Re: Doris North Water License Pre-Hearing Technical Meeting Information Supplement – New Material for Item #10 (Sewage Treatment Plant)

Item #10 – Sewage Treatment Plant Process Design Change

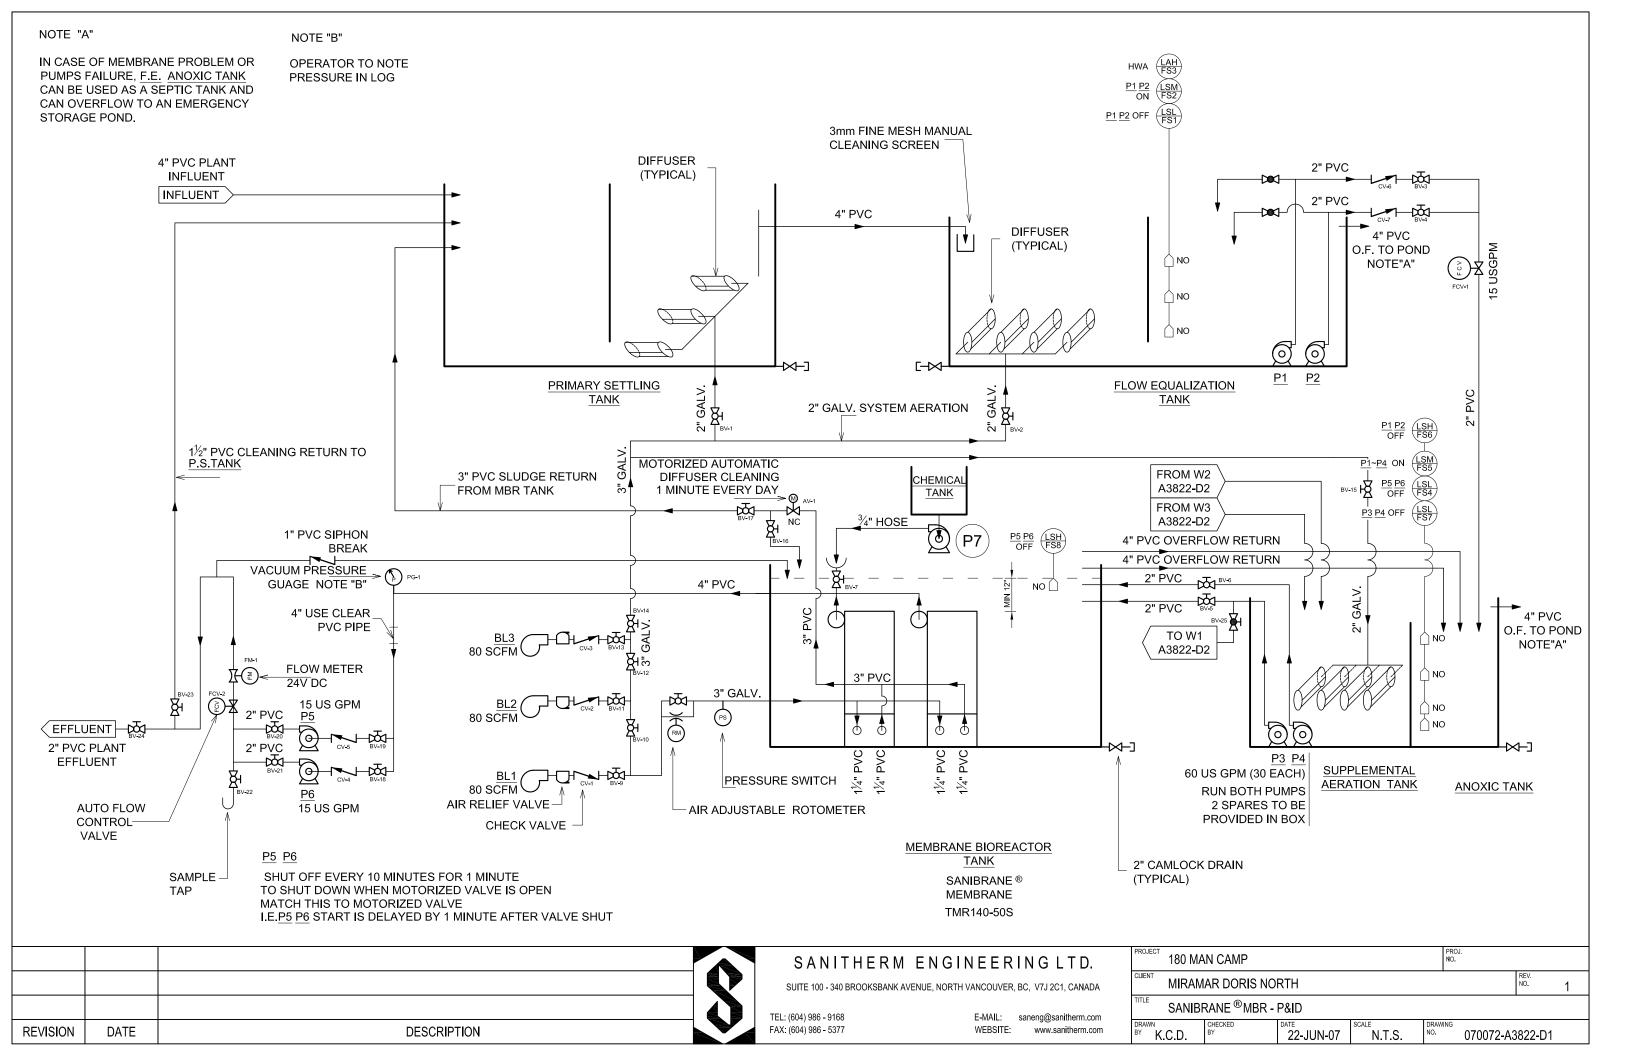
Following our submission of the June 25th "Water License Pre-Hearing Technical Meeting Information Supplement" we received additional engineering design drawings from Sanitherm Engineering Ltd. for the planned Doris North SaniBrane membrane bio reactor sewage treatment plant. Primarily these drawings show the addition of a third 40' long container to house the sludge storage and filtering equipment.

The following is replacement text for Item #10 - Sheet 1 addressing the proposed change in the planned sewage treatment plant technology. I have underlined where text has been changed from the June 25th submission for ease of review.

Based on a recommendation from SNC-Lavalin, MHBL have proposed that the Doris North packaged sewage treatment plant (STP) be changed from a rotary biological contactor type of plant as described in the April 2007 Water License application to a SaniBrane Membrane bio reactor similar to the units installed at the Snap Lake and Diavik Diamond Mine Projects. These newer membrane bioreactor sewage treatment systems are reported to be easier and cheaper to maintain and operate in Northern Climates and achieve better treatment levels than the rotary biological contactors. A flowsheet for the proposed Doris North Membrane Bio-reactor STP is presented in <u>Sanitherm Drawings 070072-A3822-D1 and 070072-A3822-D2</u>. The STP would come to site pre-constructed inside three 40' long shipping containers. A plan view of this STP arrangement is presented in Sanitherm Drawings 070072-A3822-P01, 070072-A3822-P02 and

<u>070072-A3822-P05</u>. Cross-sectional plans for the <u>three</u> containers are presented in <u>Sanitherm Drawings 070072-A3822-P03, 070072-A3822-P04 and 070072-A3822-P05 respectively.</u>

As part of this change/modification all sewage sludge will now be filtered, bagged, dried and then incinerated on site rather than being pumped to the tailings containment area for co-disposal with the tailings. The treated grey water will still report to Tail Lake as previously planned. The volume of dried sludge to be incinerated is small and is not expected to have any significant impact on air quality emissions from on-site camp incinerator.
